SUBJECT: Addendum No. 1  
Trust for Public Land  
Battlefield Connector Multi-Use Trail

## ADDENDUM NO. 1

### BATTLEFIELD CONNECTOR MULTI-USE TRAIL

#### TRUST FOR PUBLIC LAND CTI PROJECT NO. G23012-01

**TYPE I HANDRAIL NOTES**

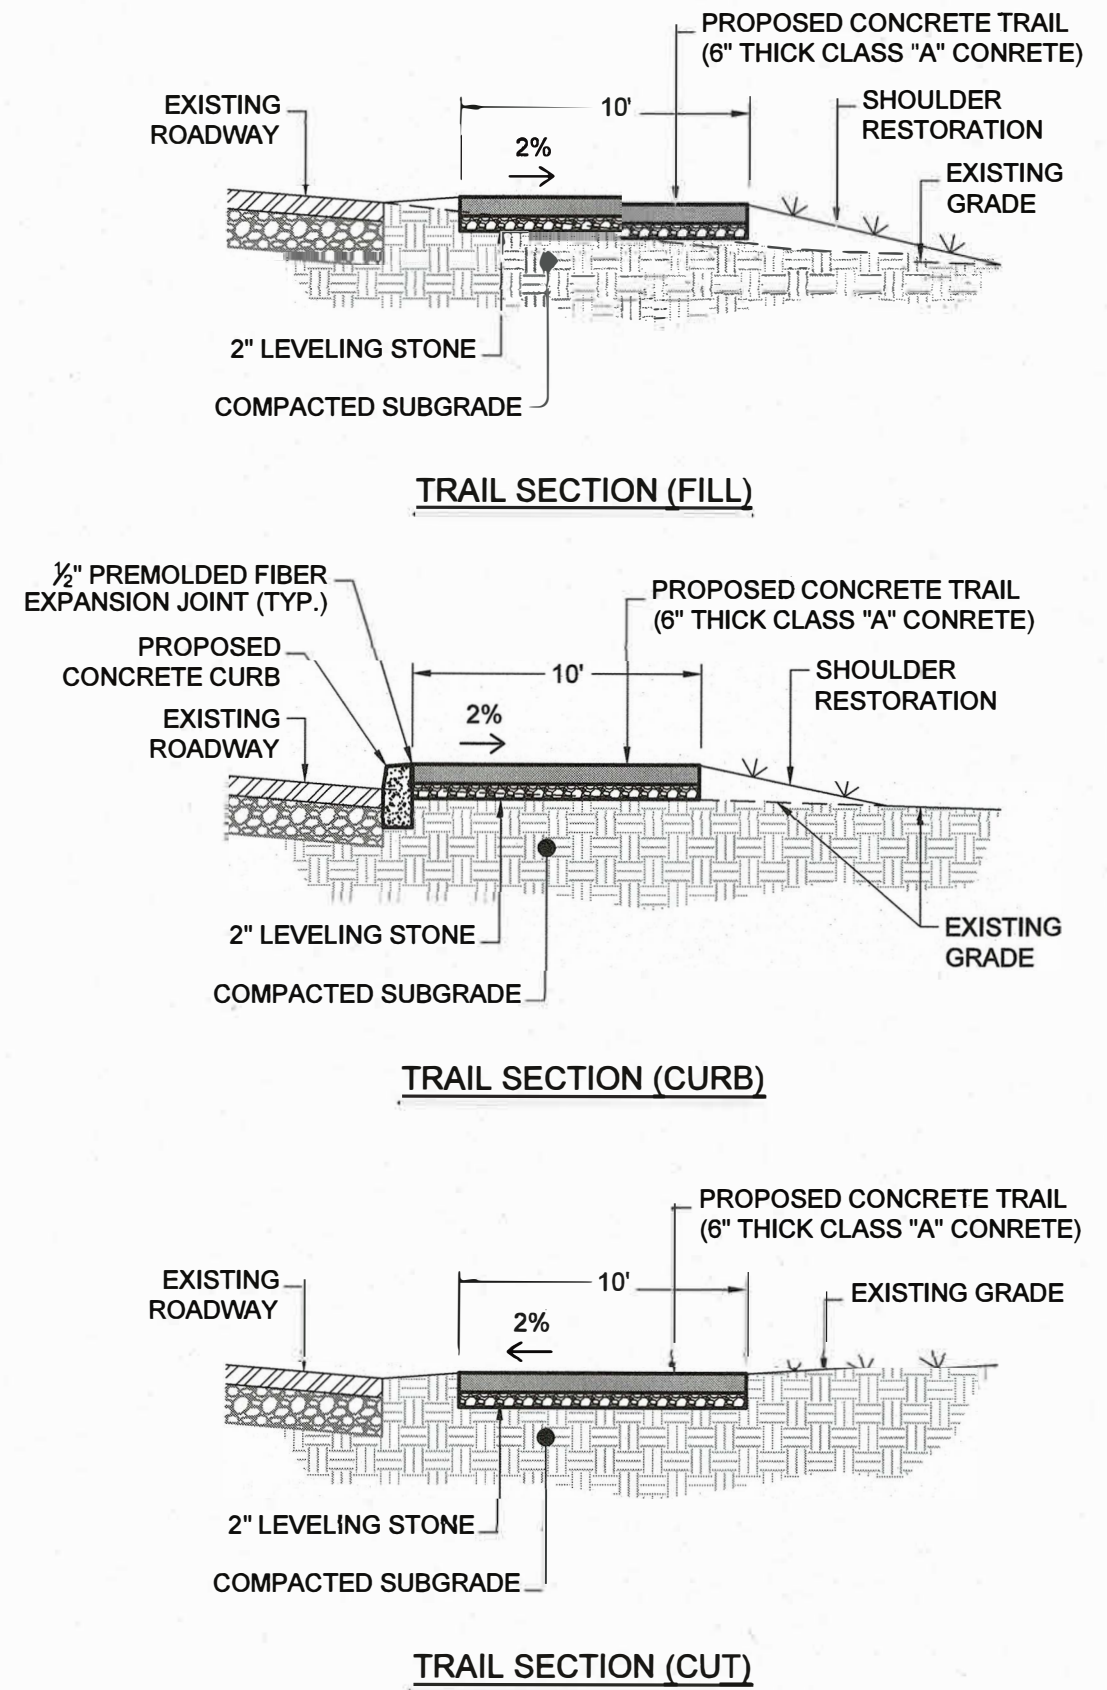
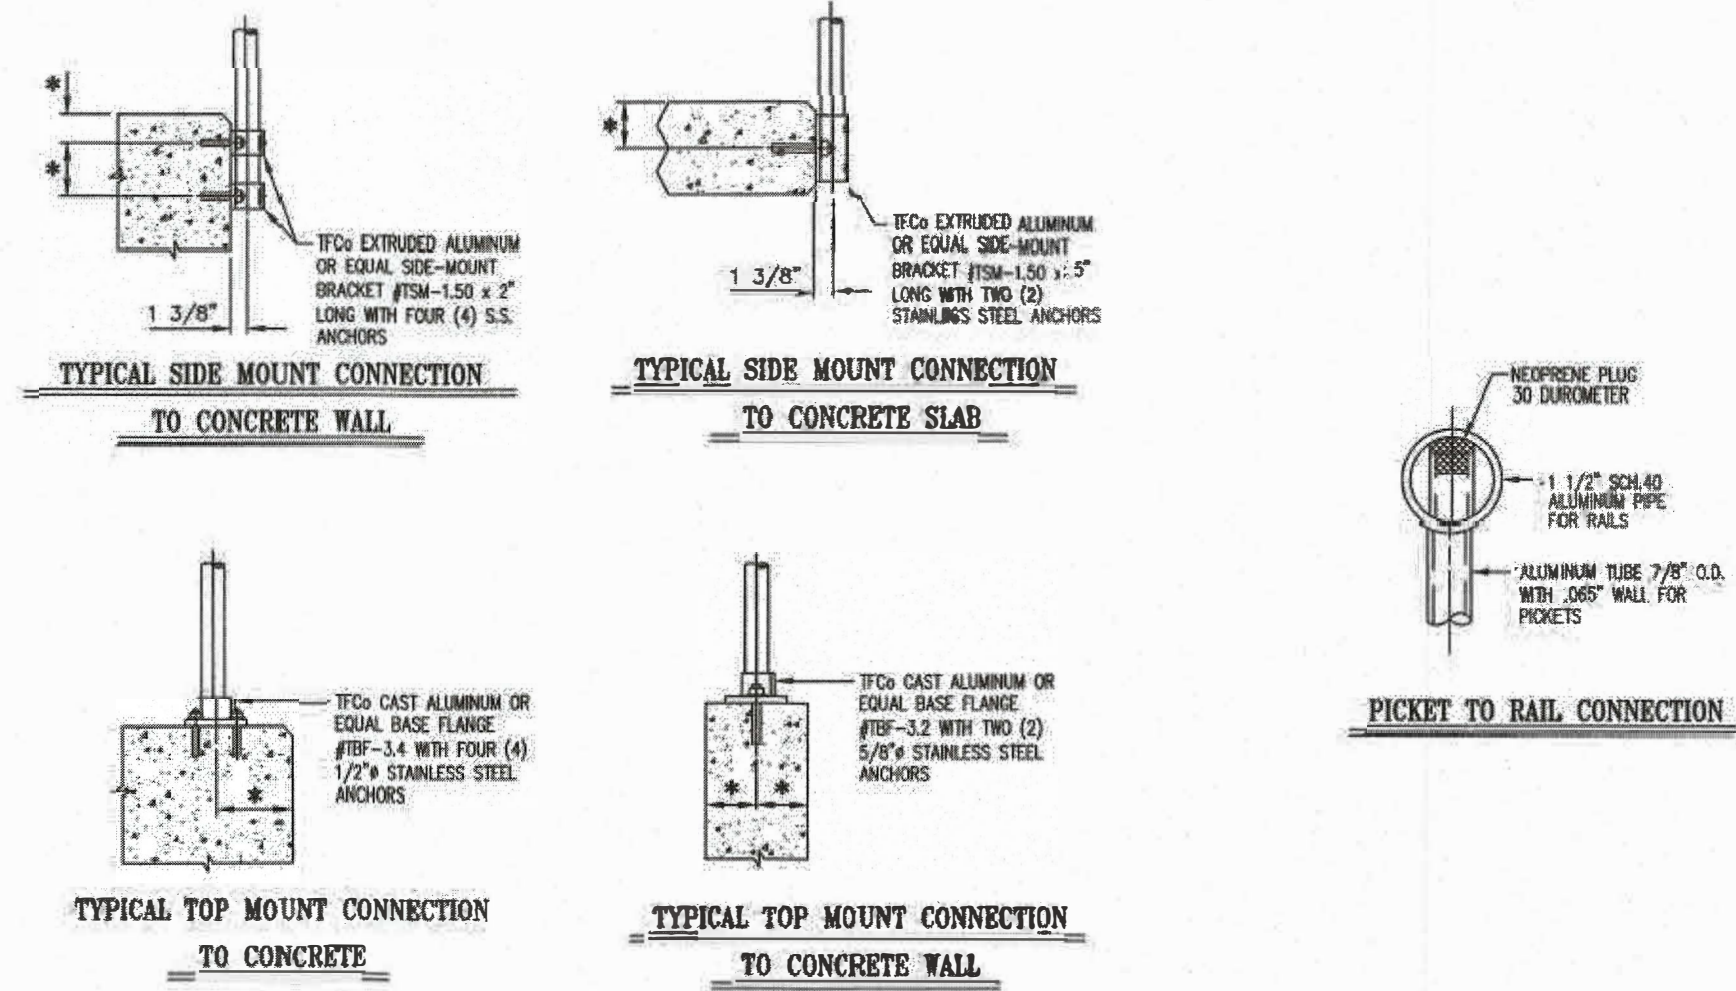
- ##### A. DELETE Drawing C-401, Standard Details and REPLACE with the attached Drawing, C-401.01.
- a. Add "Typical Type I Hand Rail" Detail.

- Handrails shall be the product of a company normally engaged in the manufacture of pipe railing. Railing shall be shop assembled in lengths not to exceed 24 feet for field erection.

- The handrail shall be made of pipes joined together with component fittings. Samples of all components, bases, toe plate and pipe shall be submitted for approval at the request of the engineer. Components that are pop-riveted or glued at the joints will not be acceptable. All components must be mechanically fastened with stainless steel hardware. Handrail and components shall be TUFlex, as manufactured by Thompson Fabricating, LLC (Birmingham, Alabama) or an approved equal.

- Railings shall be 1 1/2" Schedule 40 aluminum pipe alloy 6105-T5, ASTM-B-429 or ASTM-B-221. Posts shall be 1 1/2" Schedule 80 aluminum pipe of the same alloy. Post spacing shall be a maximum of 6'-0".

- Handrails shall be designed to withstand a 200 lb concentrated load applied in any direction and at any point on the top rail. Handrails shall also be designed to withstand a uniform load of 50 lb/ft applied horizontally to the top rail. Uniform loads are not to be applied simultaneously with the concentrated loads.

- Pickets and intermediate railings shall be provided such that a 4-inch diameter sphere cannot pass through any opening up to a height of 34 inches. From a height of 34 inches to 42 inches above the adjacent walking surface, a sphere 8 inches in diameter shall not pass. The triangular openings formed by the riser, tread and bottom rail at the open side of a stairway shall be of a size such that a sphere of 6 inches in diameter cannot pass through the opening.

- Pickets and intermediate railings shall be designed to withstand a horizontally applied normal load of 50 lb on an area not to exceed one square foot including openings and space between rails.

- The manufacturer shall submit calculations for approval at the request of the Engineer. Testing of base coatings or base extrusions by an independent lab or manufacturer's lab (if manufacturer's lab meets the requirements of the Aluminum Association) will be an acceptable substitute for calculations. Calculations will be required for approval of all other design aspects.

- Posts shall not interrupt the continuation of the top rail at any point along the railing, including corners and end terminations (OSHA 1910.23). The top surface of the top railing shall be smooth and shall not be interrupted by projected fittings.

- The mid-rail at a corner return shall be able to withstand a 200 lb load without loosening. The manufacturer is to determine this dimension for their system and provide physical laboratory tests to confirm compliance.

- Concrete anchors shall be stainless steel type 303 or 304 and shall be furnished by the handrail manufacturer. The epoxy (see specs) anchor design shall include the appropriate reduction factors for spacing and edge distances in accordance with the manufacturer's published data.

- Toe plates shall conform to OSHA standards. Toe plate shall be a minimum of 4" high and shall be an extrusion that attaches to the posts with clamps that will allow for expansion and contraction between posts. Toe plates shall be set 1/4" above the walking surface. Toe plates shall be provided on handrails as required by OSHA and/or as shown on drawings. Toe plates shall be shipped loose in stock lengths for field installation.

- Openings in the railing shall be guarded by a self-closing gate (OSHA 1910.23). Safety chains shall not be used unless specifically shown on the drawings.

- Finish shall be Aluminum Association M10-C22-A41 (215-R1). The pipe shall be plastic-wrapped. The plastic wrap is to be removed after erection.
  - Aluminum surfaces in contact with concrete, grout or dissimilar metals will be protected with a coat of bituminous paint, mylar isolators or other approved material.

- \* Concrete anchor diameter, edge distances, embedment, as well as post spacings, to be determined upon anchor selection.
